# HISTORIC AND DESIGN REVIEW COMMISSION

**HDRC CASE NO:** 2022-055  
**COMMON NAME:** 1014 N CHERRY  
**ADDRESS:** 1012 N CHERRY  
1014 N CHERRY  
**LEGAL DESCRIPTION:** NCB 512 BLK 25 LOT 6 HS  
NCB 512 BLK 25 LOT 5 & W 57 FT OF N 52.9 FT OF 10  
**ZONING:** RM-6, H  
**CITY COUNCIL DIST.:** 2  
**DISTRICT:** Dignowity Hill Historic District  
**APPLICANT:** Ricardo Turrubiates/Mint Development LLC  
**OWNER:** Delafield Investments, LLC  
**TYPE OF WORK:** Construction of six, 2-story residential structures  
**APPLICATION RECEIVED:** April 22, 2022  
**60-DAY REVIEW:** Not applicable due to City Council Emergency Orders  
**CASE MANAGER:** Edward Hall  
**REQUEST:**

The applicant is requesting conceptual approval to construct eight, 2-story residential structures on the vacant lots at 1012 and 1014 N Cherry Street, located within the Dignowity Hill Historic District.

# Site Plan

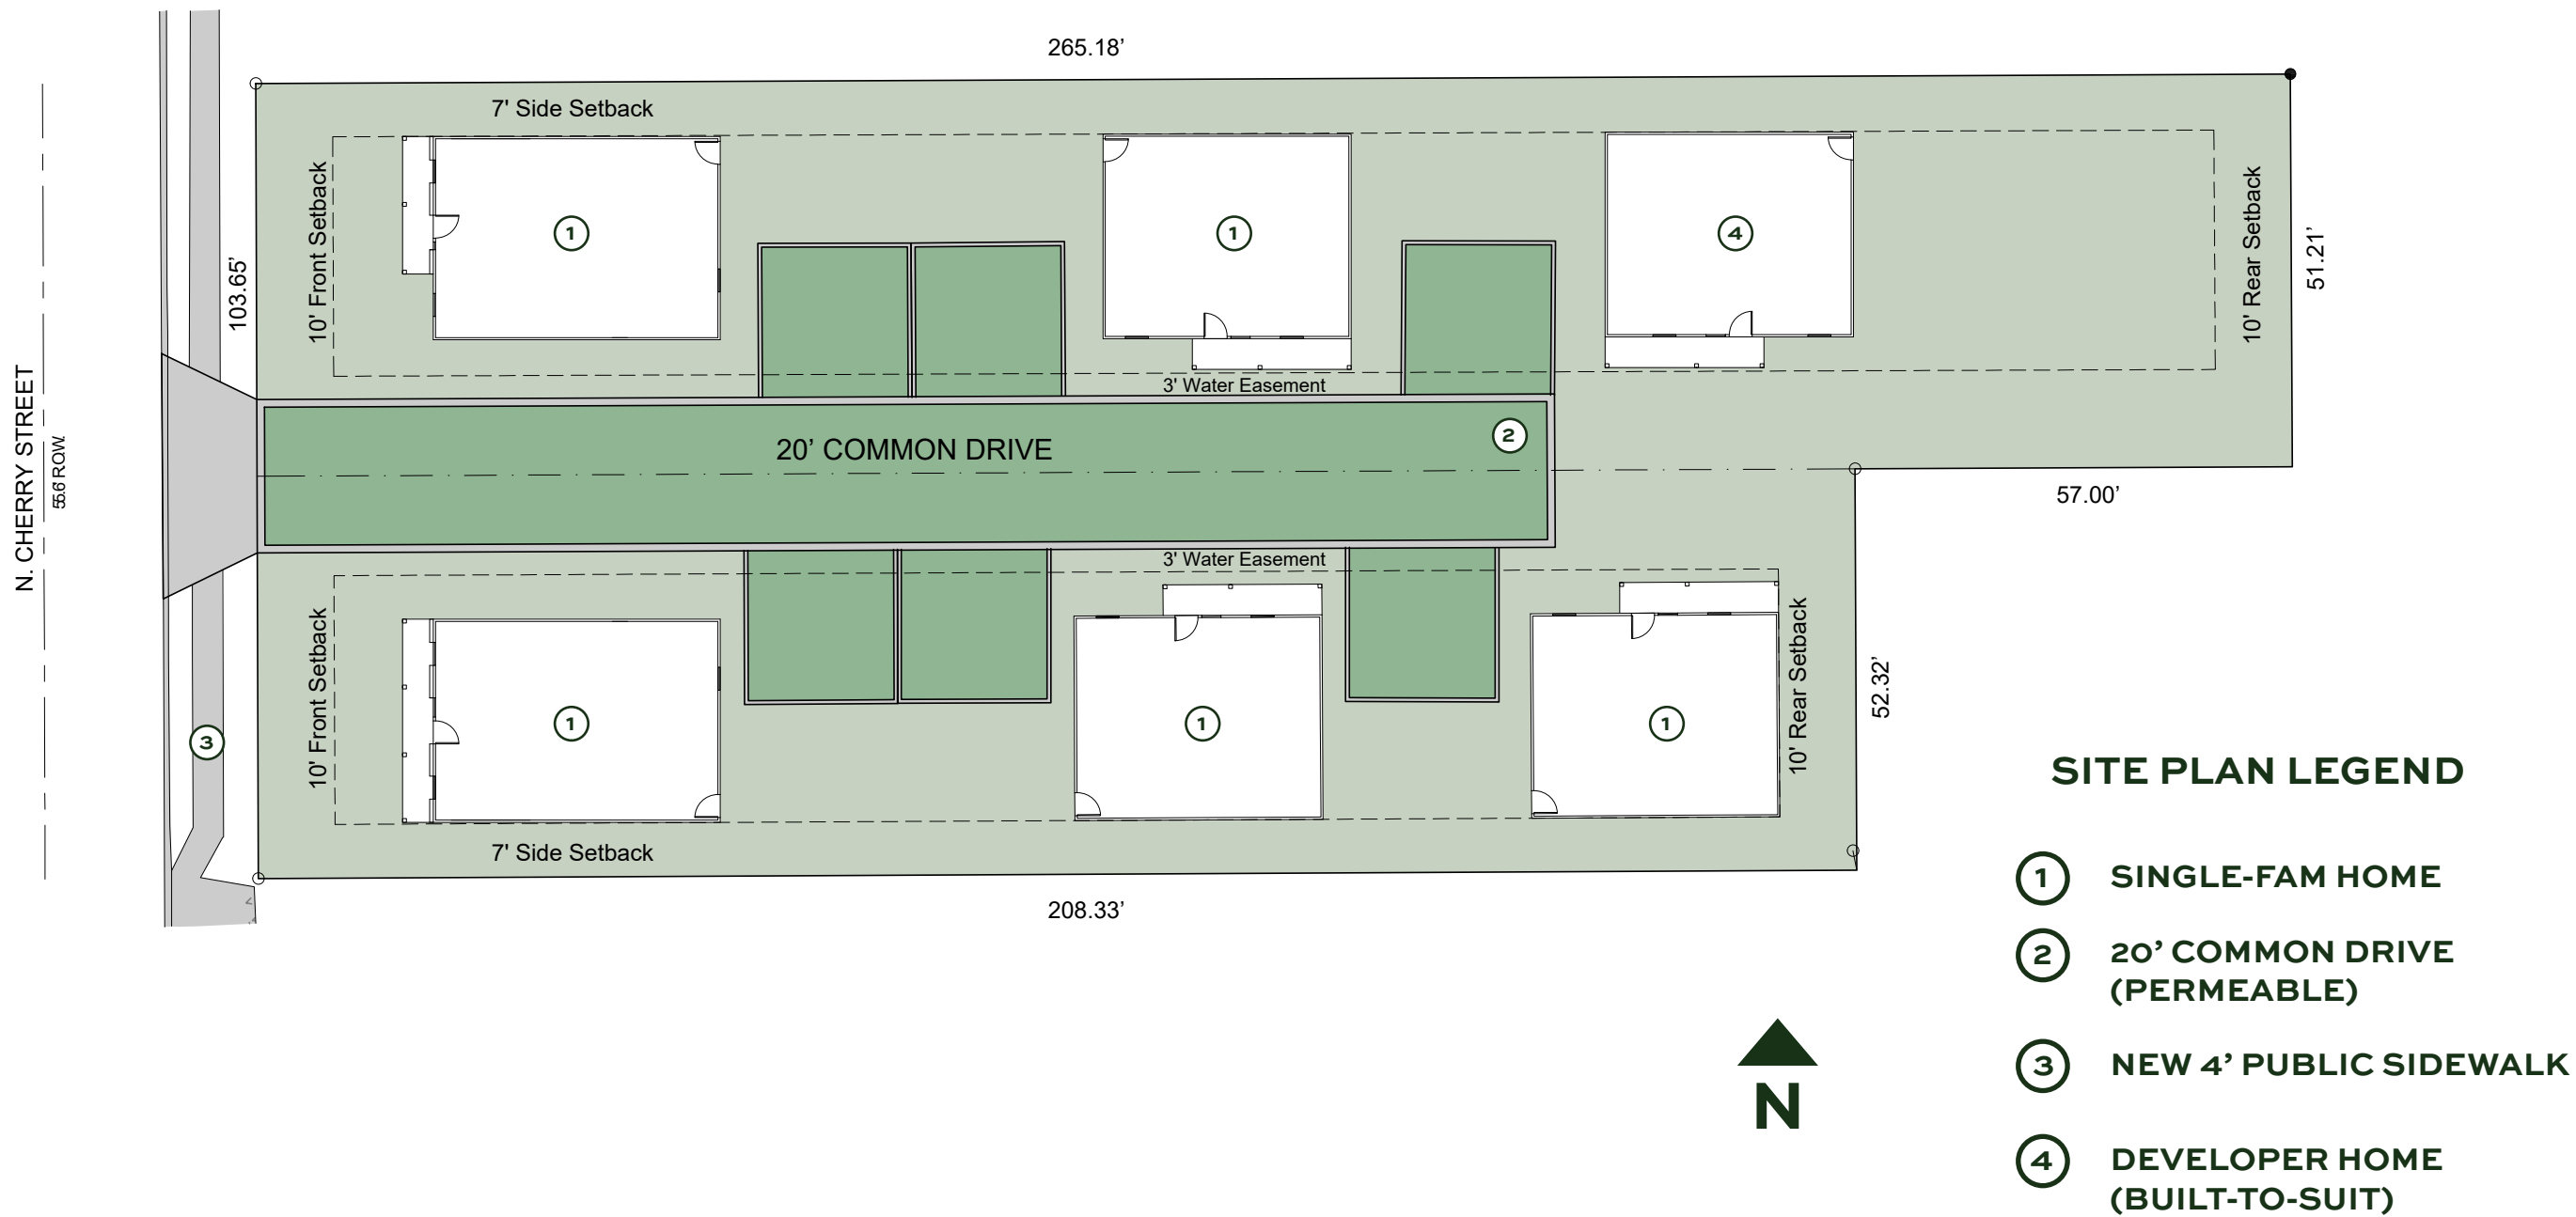
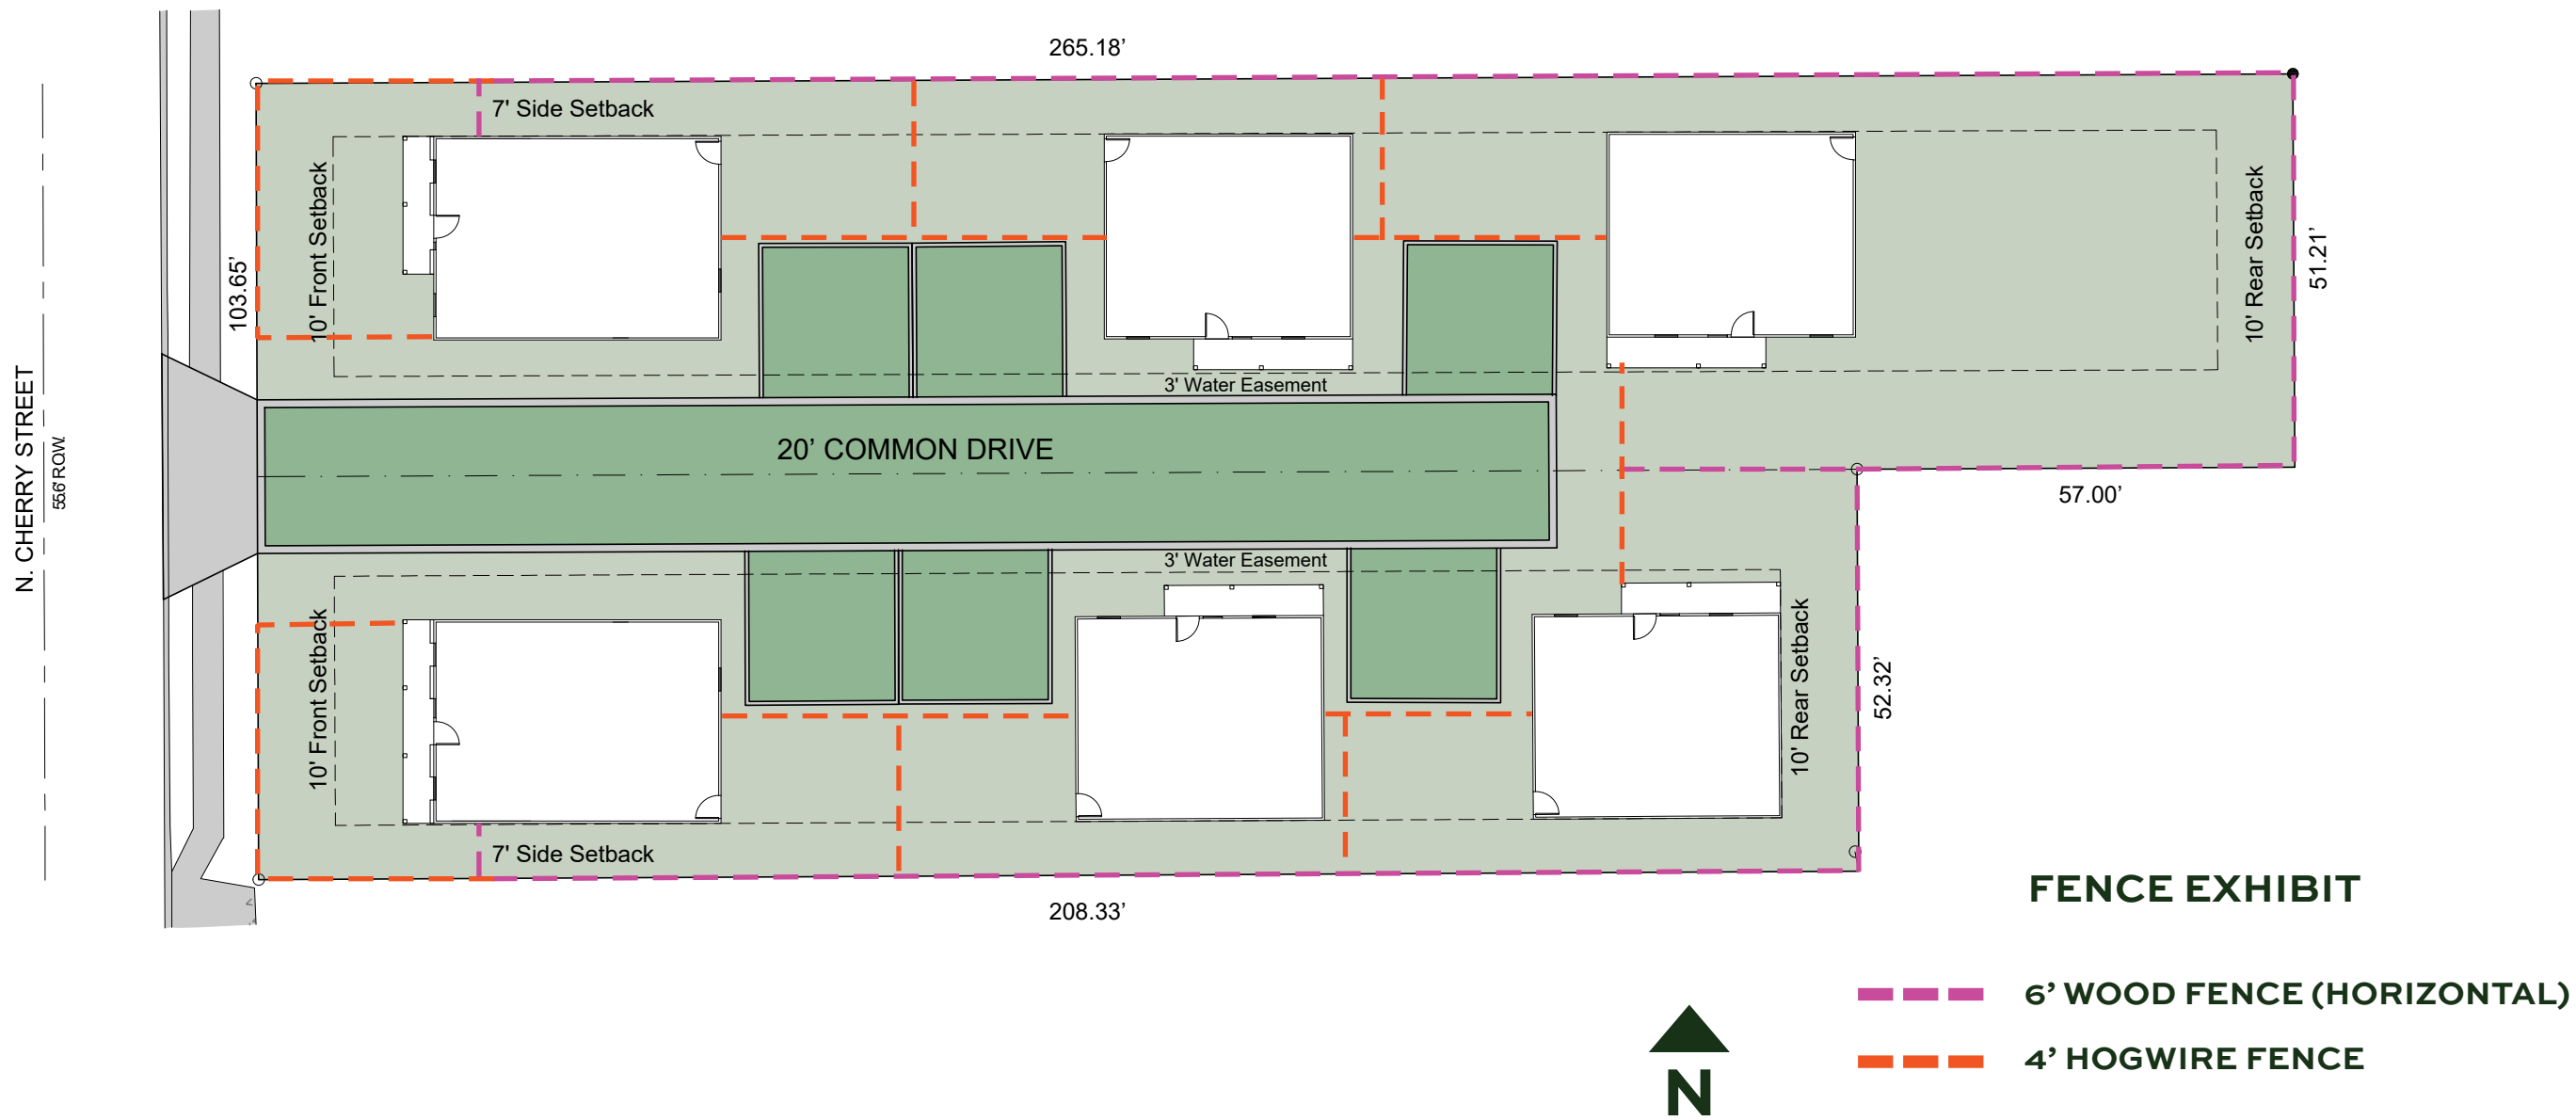
- e. **SETBACKS** – As noted in finding a, the applicant has proposed for two of the eight structures to feature street frontage and an orientation towards N Cherry. The Guidelines recommend that, in instances where front yard setbacks of historic houses are varied on a block face, new construction should feature a front yard setback that is the median of houses on the block face. The applicant has submitted a setback diagram providing the front setbacks of 1010, 1018, 1024, and 1026 N Cherry. The median setback of the four structures oriented towards N

Cherry is approximately thirty-two (32) feet. The applicant has proposed setbacks for the new construction on N Cherry of 30' – 0" and 31' – 5" when measured from the curb. Staff finds that an increased setback would be most appropriate. Per the site plan, there appears to be room to increase both front setbacks.

- q. DRIVEWAY – The applicant has proposed for automobile traffic to enter the side from N Cherry via a driveway that features twenty (20) feet in width. The proposed driveway will feature permeable paving. Mid-block alleys are often found throughout the Dignowity Hill Historic District; however, none existed historically on this block of N Cherry. Staff finds a driveway of twenty (20) feet in width to be inconsistent with the Guidelines, as the Guidelines recommend driveway widths of no more than ten (10) feet. Additional driveway widths may be appropriate internally to the site if the traditional driveway location within the front and side yards of the structures that front N Cherry is maintained at ten (10) feet.

- r. FRONT WALKWAYS – Houses on this block of N Cherry feature front walkways that lead from the front porch to the sidewalk at the public right of way. Per the site plan, the applicant has not proposed to incorporate walkways. Staff finds that both structures that front N Cherry should feature front walkways that are consistent with the Guidelines regarding profile and materials.

MS: Can the setbacks be addressed (south house is probably fine, but north house should be increased). FZ: North house could probably be pushed back a bit further.

- i. That the site plan be developed to better document conformance with the Guidelines.
- ii. That the applicant increase the proposed front setbacks, as noted in finding e. Per the revised site plan, there appears to be room to increase the front setbacks.

- viii. That both structures that front N Cherry feature a front walkway to connect the front porches to the sidewalk at the right of way, as noted in finding r.

- ix. That the proposed driveway be reduced to no more than ten (10) feet in width, as noted in finding q.
- x. That all mechanical equipment is screened from view from the right of way and that a detailed landscaping plan be developed and submitted to the Commission for review and approval, as noted in findings s and u.

FRONT ELEVATION  
HEIGHT: 29'-2"

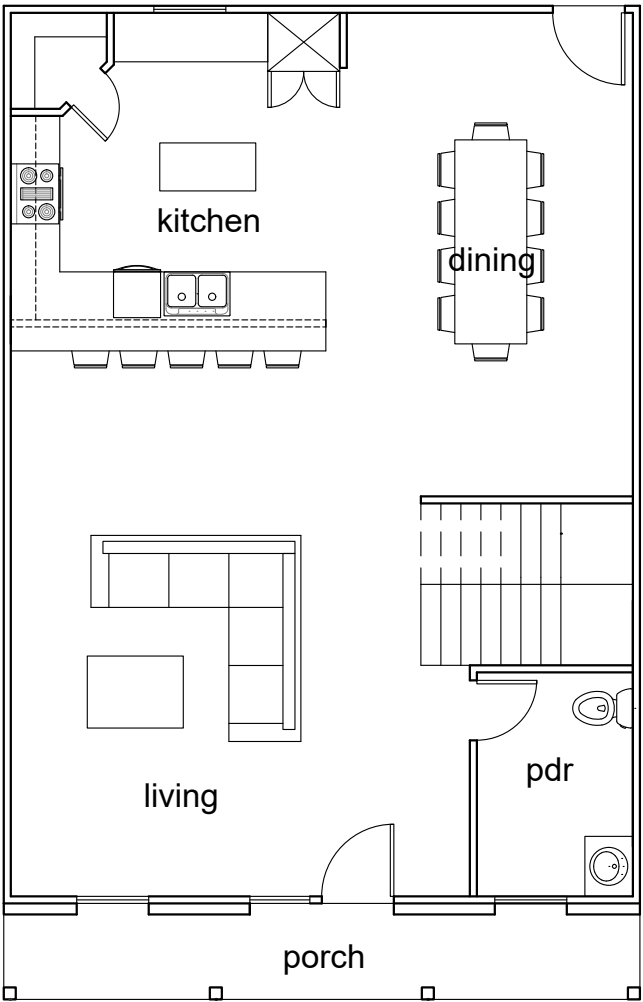
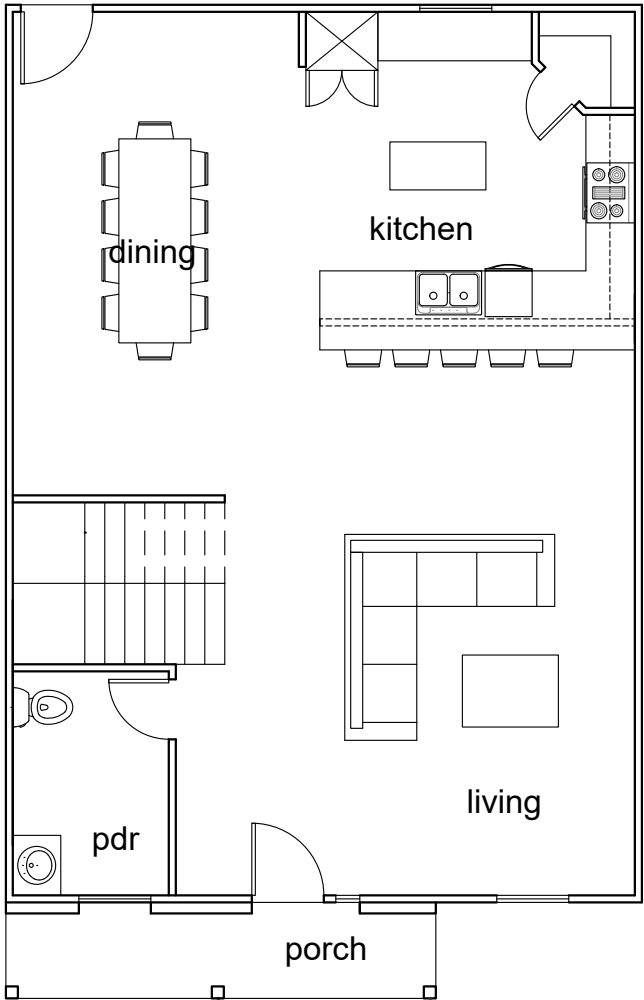
- f. **SCALE & MASS** – Per the Guidelines for New Construction 2.A.i., a height and massing similar to historic structures in the vicinity of the proposed new construction should be used. In residential districts, the height and scale of new construction should not exceed that of the majority of historic buildings by more than one-story. As noted in finding c, all of the existing, historic structures on this block feature one (1) story in height. Generally, staff finds the two story structures fronting N Cherry to be consistent with the Guidelines, as they feature one additional story in height over the existing, historic structures found on the block. However, within historic districts, the historic development pattern features rear structures with massing that is subordinate to that of the primary structure at the street. While the applicant has reduced the proposed development by two structures, staff finds the overall massing to be inconsistent with the Guidelines in regards to height and building footprint, as the historic development pattern throughout the district typically consists of rear structures featuring reduced massing and footprints in comparison to primary, street fronting structures. Additionally, staff finds that the applicant should submit a street elevation noting the proposed heights of new construction in relationship to existing, historic structures.

- i. **ROOF FORMS** – The applicant has proposed roof forms to include front facing gabled roofs, hipped roofs and both hipped with a front gable. Staff finds the proposed roof forms to be appropriate; however, as noted in finding f, staff finds that a reduction in massing for each of the six structures should be incorporated into the design. Modified roof forms or roof forms that reduce the overall massing of the proposed new construction should be used.

- j. **MATERIALS (Facades)** – The applicant has proposed materials that include terracotta brick, stucco and composite siding. The applicant has proposed for front facades to feature a combination of terracotta brick and stucco, while the side and rear facades are to feature composite siding. The Guidelines for New Construction 3.A. note that materials that complement the type, color, and texture of materials traditionally found in the district should be used. Additionally, the Guidelines state that materials should not be so dissimilar as to distract from the historic interpretation of the district. Generally, staff finds the use of terracotta brick and stucco to be inconsistent with the traditionally used materials throughout the Dignowity Hill Historic District in residential construction. Additionally, the use of multiple materials on one façade and the use of an alternative material on side and rear facades is not found historically within the district. Staff finds that lap siding that features a smooth finish and four inch exposure, or board and batten siding that features boards that are twelve inches in width with seams that are 1.5 inches in width to be most appropriate and consistent with the Guidelines.

- m. **WINDOW & DOOR OPENINGS** – The Guidelines for New Construction note that window and door openings should be comparable to those found historically within the district. Generally, staff finds the proposed window and door openings to be appropriate and consistent with the Guidelines; however, staff finds that rectangular, fixed windows on the front facades should be modified to feature traditional sizes and feature a one over one profile. Generally, staff finds the contemporary side lites adjacent to the proposed front doors to be appropriate.

- iii. That the applicant decrease massing on site as noted in finding f. A reduction in building footprint or lowering of height to single story for some structures would be more appropriate.

- iv. That traditional materials be used in place of the proposed terracotta brick and stucco, as noted in finding j, and that façade materials be consistent on each façade with those found historically in residential construction within the district. Siding should be consistent with staff's standards specifications, as noted in finding j.

- vii. That the rectangular, fixed windows on the front façade be eliminated for traditionally sized windows in a one over one profile, as noted in finding m.
